From: Torpoint Town Council <admin@torpointtowncouncil.gov.uk>
Sent: 03 May 2024 11:33
To: Milly Southworth
Subject: FW: Torpoint A374 speed readings

Subject: Torpoint A374 speed readings

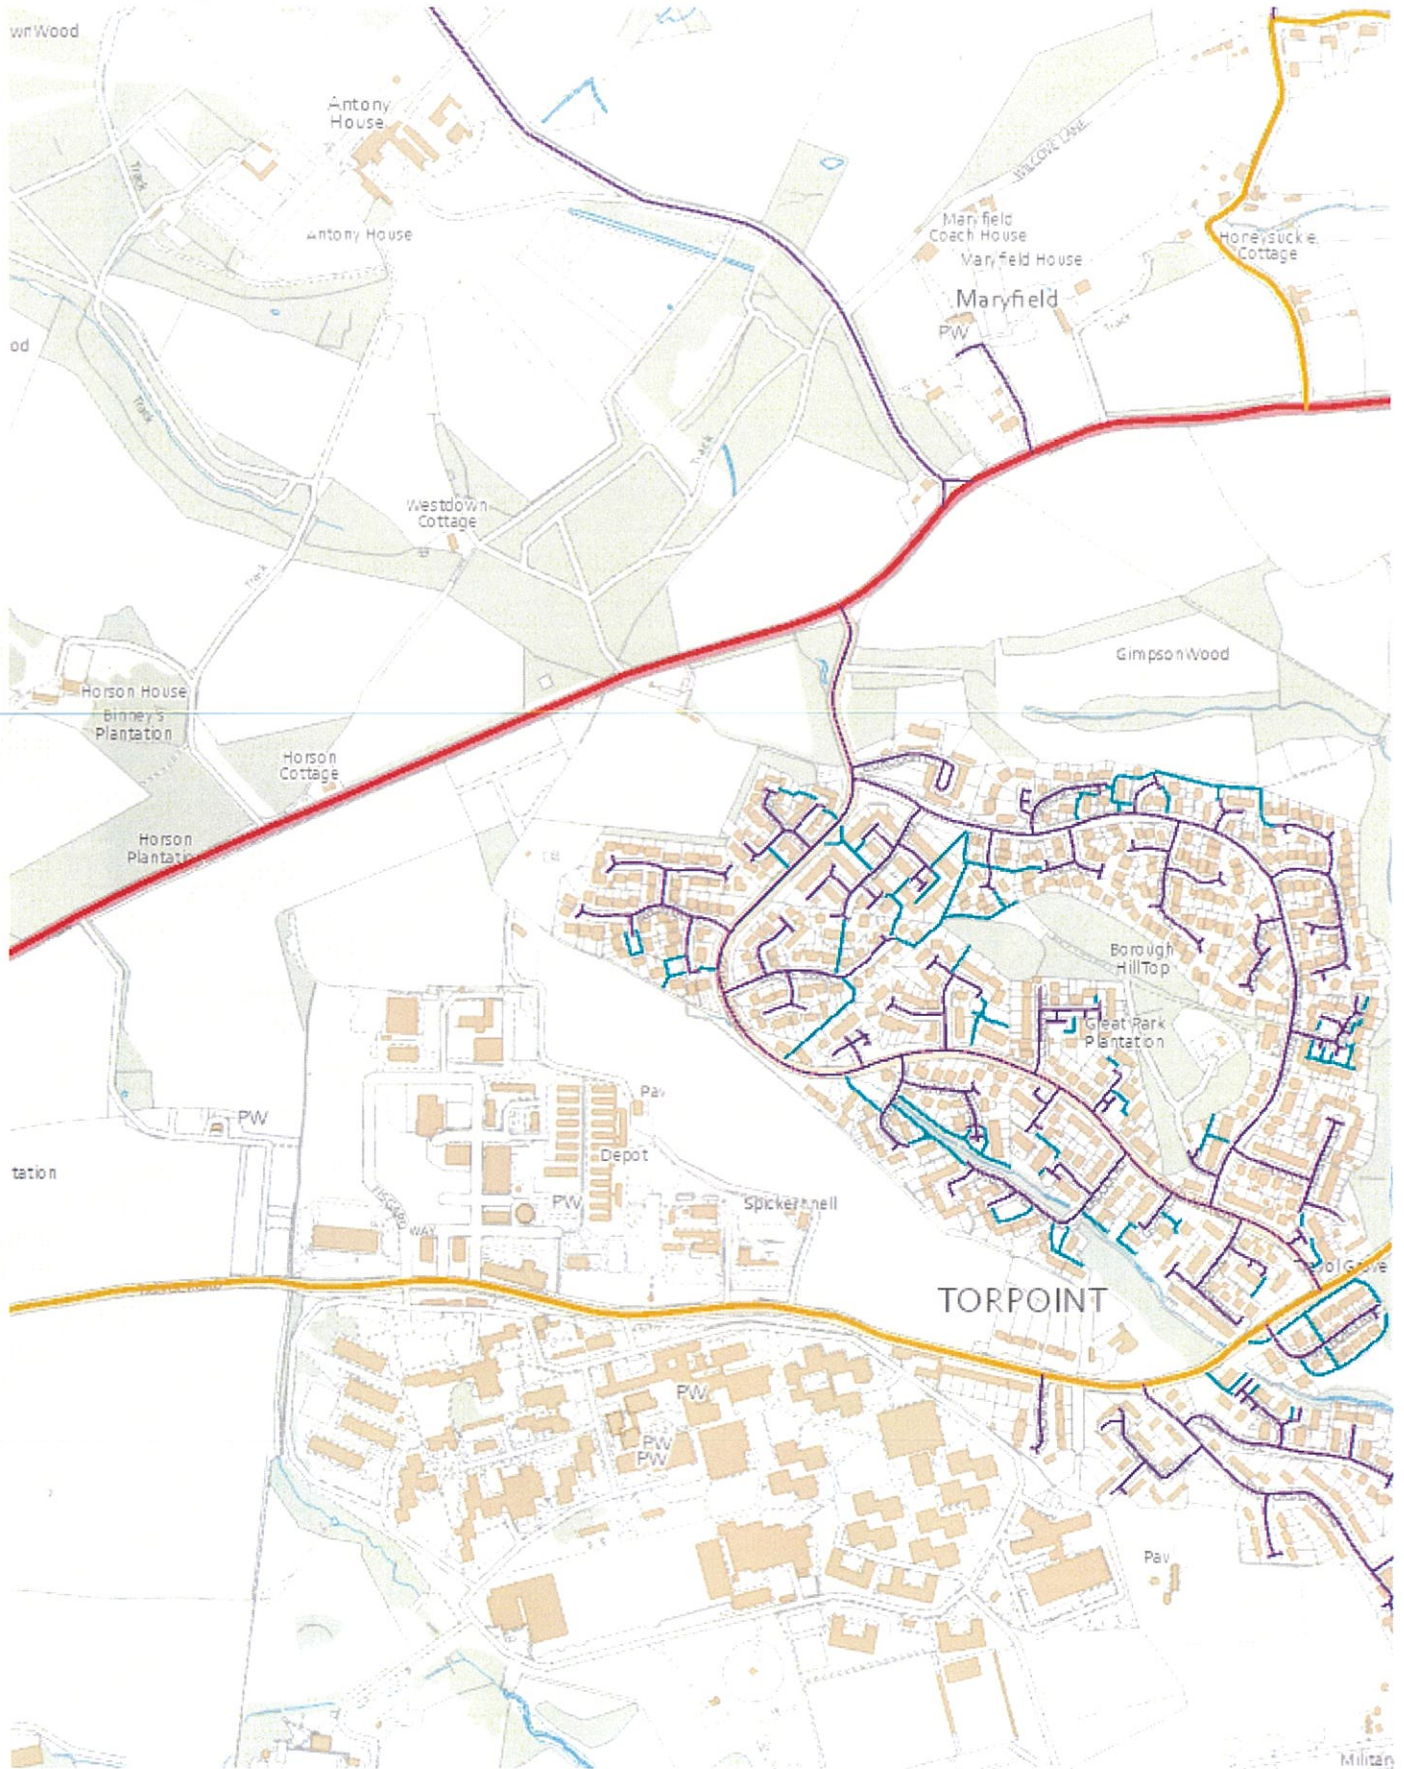
This may sound a little draconian. In the first instance would it not be better to have a police presence on and off over a few days as the road all the way to the eastern entrance to Wilcove is now 30mph which I think we should enforce rather than now "up" this to 40 mph. Kate and I were both in favour of this extension of the 30 mph (only in

place for last 18 months or so?) as were the residents of Wilcove. I, along with Kate no doubt, plus the residents of Wilcove would see this as a backward measure.

We have some concerns regarding the 30mph extents on the A374. The Site 2 speed readings is showing we had circa. 4,000 vehicles travelling over 40mph within the 30mph section, demonstrating the 30mph is over-extended.

We're proposing to reduce the 30mph extents, but would still cover the college. On the below, the 30mph would be roughly where the blue line is. A 40mph buffer would be north-west of that line (hopefully reducing speeds of those 4,000 vehicles). If we have 30mph signs in the correct location, it would also hopefully reduce vehicle speeds past the college. Currently the 30mph signs are being ignored and speeds are therefore still too high past the college.
